# UNITED STATES PATENT AND TRADEMARK OFFICE

| APPLICATION NO.                  | FILING DATE   | FIRST NAMED INVENTOR | ATTORNEY DOCKET NO. | CONFIRMATION NO. |
|----------------------------------|---------------|----------------------|---------------------|------------------|
| 10/598,613                       | 05/29/2007    | Marc Peuker          | 59109US004          | 7832             |

| <b>Office Action Summary</b> | <b>Application No.</b> | <b>Applicant(s)</b> |  |

## **DETAILED ACTION**

**FIG. 8**

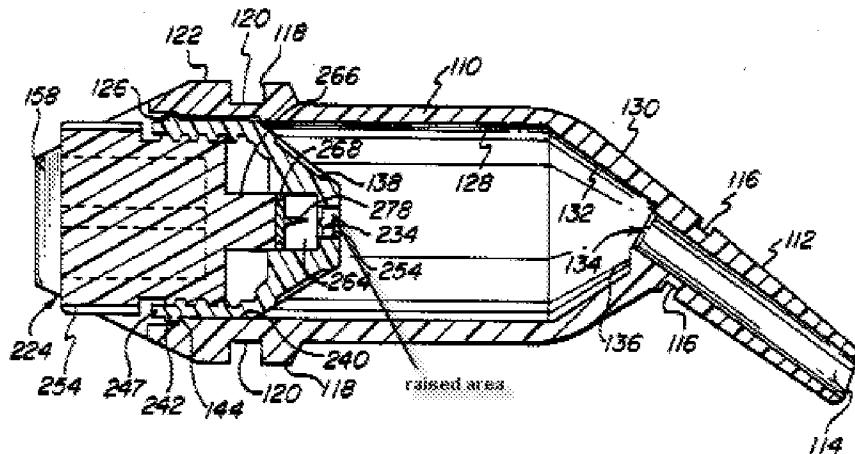
**However Dragan discloses a separation wall 138 comprise a raised area (see figure above) extending towards said activator member 266.**

**It would have been obvious to one having ordinary skill in the art at the time the invention was made to have a raised area included in the separation wall as taught by Dragan, since Dragan shows in Fig 8 that such a modification would allow the two substances an area to begin to mix together.**

**However Dragan discloses (Fig 8) the raised area (see figure above) comprises an annular bulge.**

**It would have been obvious to one having ordinary skill in the art at the time the invention was made to have the raised area included in annular bulge as taught by Dragan, since *Dragan* shows in Fig 8 that such a modification would allow the two substances an area to begin to mix together in a curvature manner.**

**However Dragan discloses a separation wall 138 comprise a raised area (see figure above) extending towards said activator member 266.**

**It would have been obvious to one having ordinary skill in the art at the time the invention was made to have a raised area included in the separation wall as taught by Dragan, since Dragan shows in Fig 8 that such a modification would allow the two substances an area to begin to mix together.**

**However Dragan discloses (Fig 8) the raised area (see figure above) comprises an annular bulge.**

**It would have been obvious to one having ordinary skill in the art at the time the invention was made to have the raised area included in annular**

**bulge as taught by Dragan, since Dragan shows in Fig 8 that such a modification would allow the two substances an area to begin to mix together in a curvature manner.**
